Presentation of the Final Report

Localized Corrosion

Peer Panel on Waste Package Materials Performance

U.S. Department of Energy (DOE)
Bechtel SAIC Company, LLC (BSC)

Localized Corrosion - Project Approach

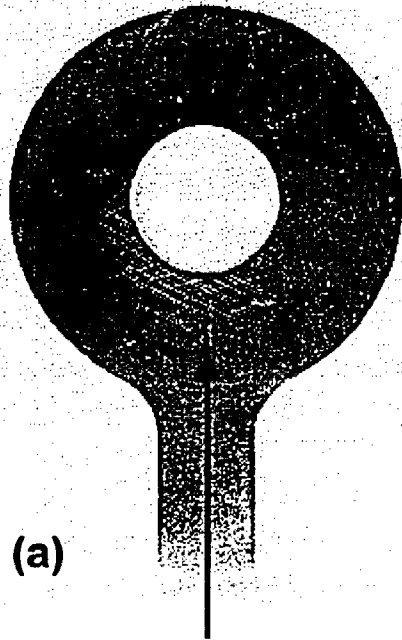
- Problems with Project approach:
 - Samples used in potentiodynamic experiments were nominally **uncreviced**.
 - **Alloys do not exhibit localized corrosion in tested environments – E_{crit} is not related to localized corrosion.** In other words, the model for localized corrosion is based on data that are unrelated to localized corrosion.
 - Does not allow extrapolation to other environments in which localized corrosion is possible.
 - E_{corr} values (zero current potentials in polarization curves) are **not indicative of long term corrosion potential**.

Localized Corrosion - Ennoblement

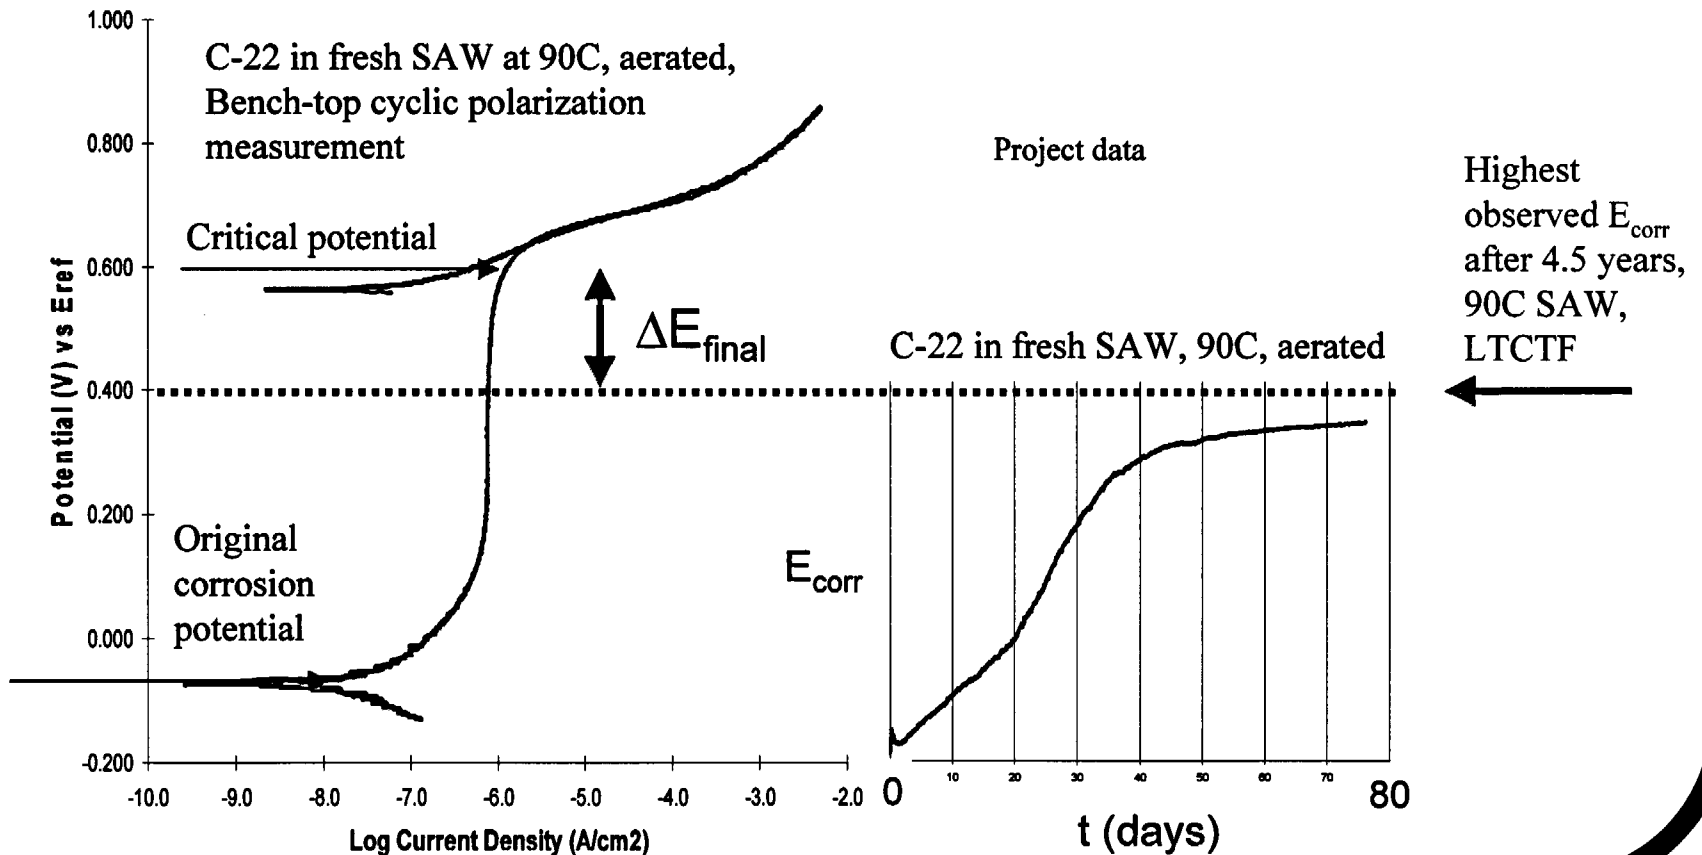
The project has measured E_{corr} to have increased by about 500 mV after 4.5 years in various solutions in the Long Term Corrosion Test Facility.

No localized corrosion was found, and the potential remained below the transpassive potential and close to the potential for Pt in that solution.

Localized Corrosion - Ennoblement

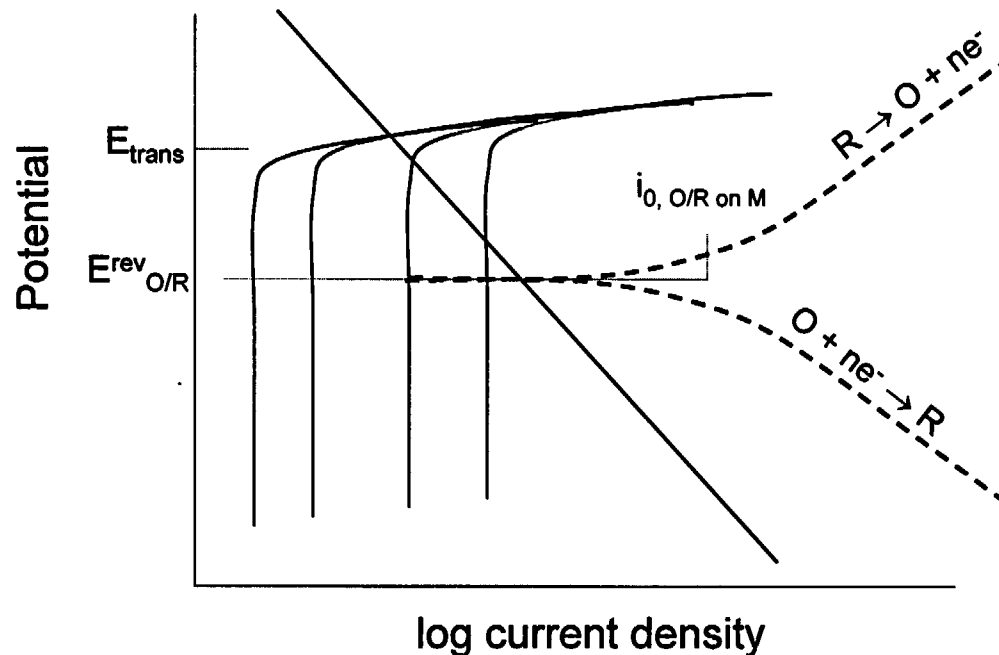
The corrosion potential might be pinned at a value below a critical potential if the solution contains a redox reaction with an exchange current density that becomes large relative to the passive current density as the passive current density decreases. Based on the potential of Pt, this seems to be happening over long times in SAW.

ΔE might get small with time, but that is not bad if E_{corr} stays below a conservative E_{crit} , such as $E_{\text{r,crev}}$.
